Service Letter Number 426

SUBJECT: Crankshaft Propeller Flange Inspection, per Lycoming Service Bulletin No. 300 and

Service Bulletin No. 300A
Approved by FAA

SUBJECT: Crankshaft Propeller Flange Inspection

Figure 1. Rear View of Propeller Mounting Flange Showing Area of Lightening Holes.

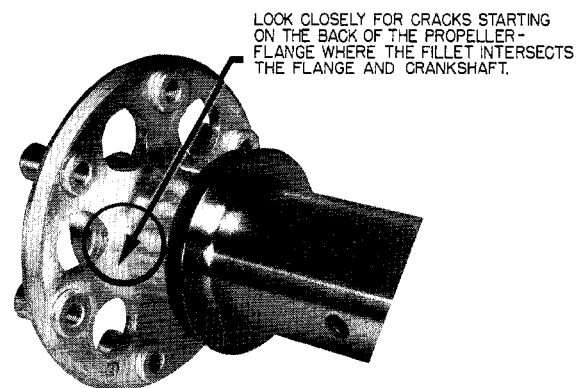
a. Remove the propeller and starter ring gear from the mounting flange of the engine and examine the entire area of the crankshaft flange from the crankshaft seal forward for evidence of cracks. Use a magnifying glass of approximately 10 power and adequate lighting for this purpose or portable magnetic particle test equipment. Pay particular attention to the flange area and fillet radius on rear face of propeller flange. See accompanying illustrations for possible location of where cracks might appear and type of structural damage which can occur. Because of machining marks, the factory does not recommend using dye penetrant for this inspection. Further flight with a cracked propeller flange is not permissible.

Figure 2. 10X magnified view showing appearance of area cracked due to abnormal loading imposed on the propeller flange during periods of unauthorized maneuvers.

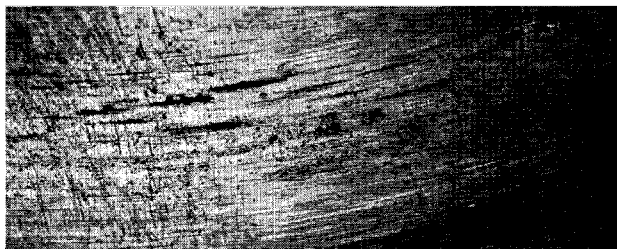
a. During magnetic particle inspection, particular care should be taken to examine the propeller flange area in the large fillet radius tangent to the crankshaft in addition to the normal flange and shaft areas for possible cracks or other evidence which indicates bending.
